17 June 2016
General Manager
Camden Council
John Street
Camden 2570

**Re DA 169/2016
Camden Vale Milk Depot**

**Demolition, alterations, additions to the existing Camden Vale Milk buildings
for five new restaurants and a function centre, provision of car parking, associated
tree removal, landscaping and site works**

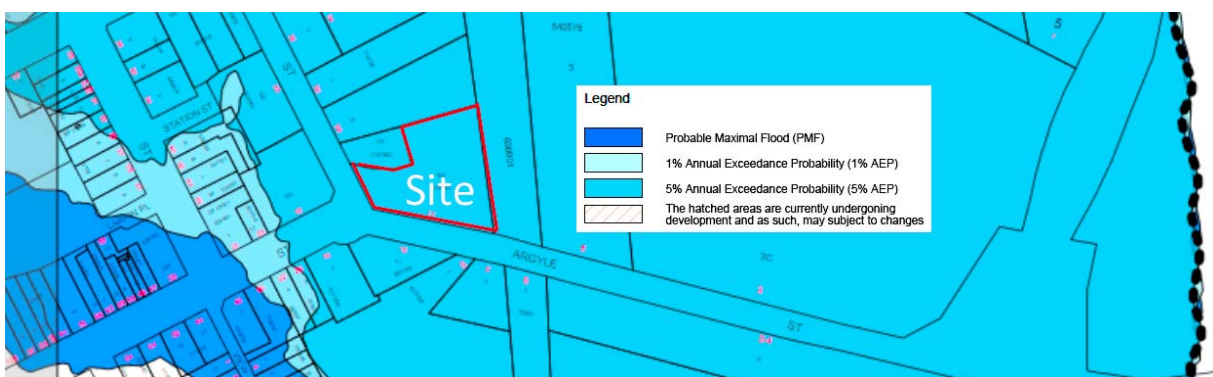
The Milk Depot site (see map below) is unequivocally, according to Appendices I and J of the Flood Study, in a high hazard area floodway, which is often aligned, as in the case of the Milk Depot site, with obvious natural channels.

The Flood Study does not address the milk depot site specifically. Although the computer modelling shows the development site to be in a floodway, it does not show where the first flood water travels, or its speed in times of flood and heavy rain.

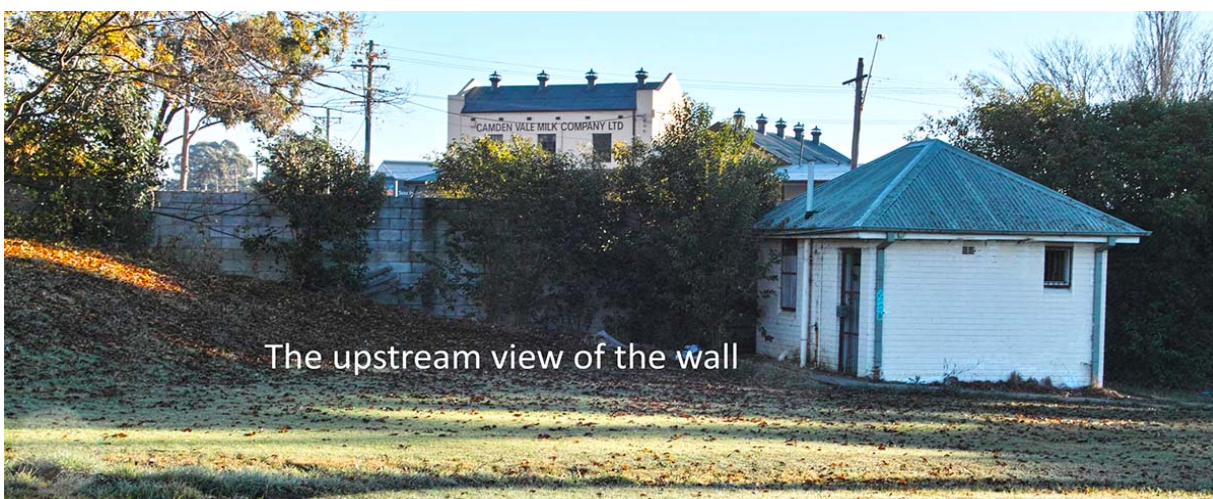
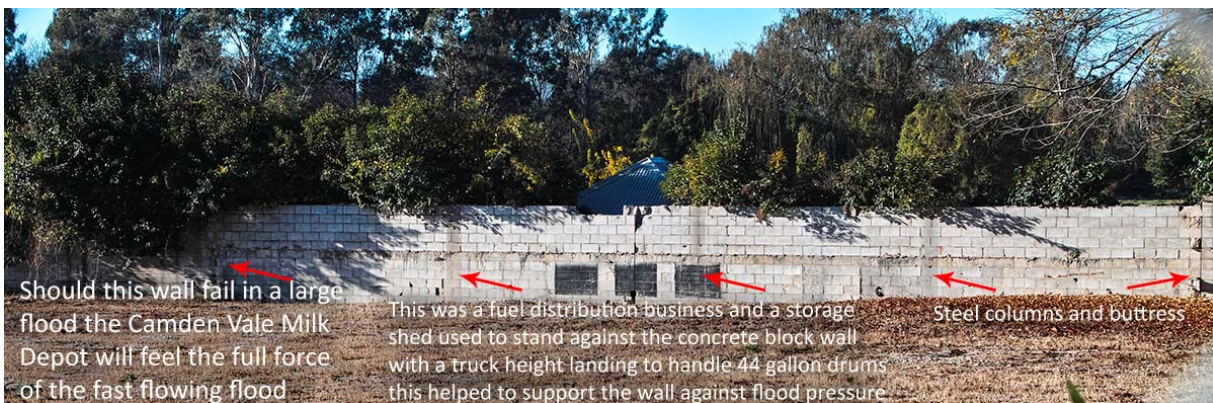
This behaviour was captured in photographs during the flood event of 5-6 June 2016 as shown below.

After only a short period of heavy rainfall on 5 and 6 June 2016, as shown in the photos above, water came to the base of the roller door of the milk depot building and resulted in a channel of fast flowing flood water. Anecdotally this is a fast flowing stream and more dangerous than the floodway generally. Although the SEE of the Milk Depot DA acknowledges that the site is in a floodway, the highest risk category in the NSW Floodplain Development Manual 2005, it is unlikely that the proponents of the Milk Depot development are fully aware of the flood hazard. Apart from being in a floodway this fast flowing channel is positively dangerous in relation to any development in its path.
